RFI

RFI#: 21 Date: 1/3/2012 Job: EB-02 Keller Springs Lofts Phone: 877-777-5115

Subject: Elevation eastside of garage Drawing: 3.1D

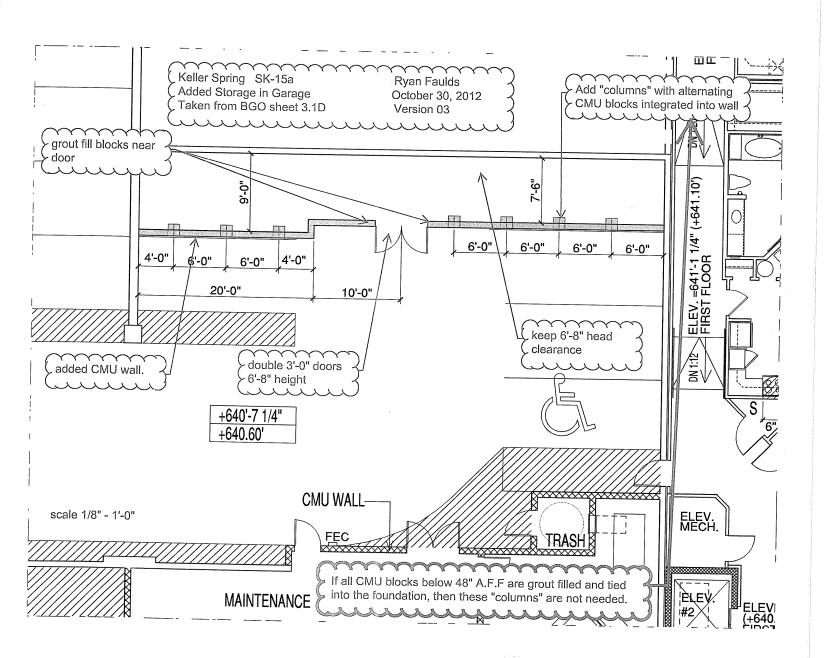
Spec Section: Cost Impact: None Schedule Impact: None Date Required: 1/10/2012 Sheet 3.1D shows elevation= 641'-1 1/4" at the corridor of the building on the eastside of garage near A4 alt G. unit and romp. Shouldn't the elevation be 641'-7 1/4"? Requested by: Bryan Pickler Embrey Partners, Ltd. Correct 641'-7 1/4" as this part of the corridor on sheet 3.1C Erik Earnshaw Answered by BGO Architects
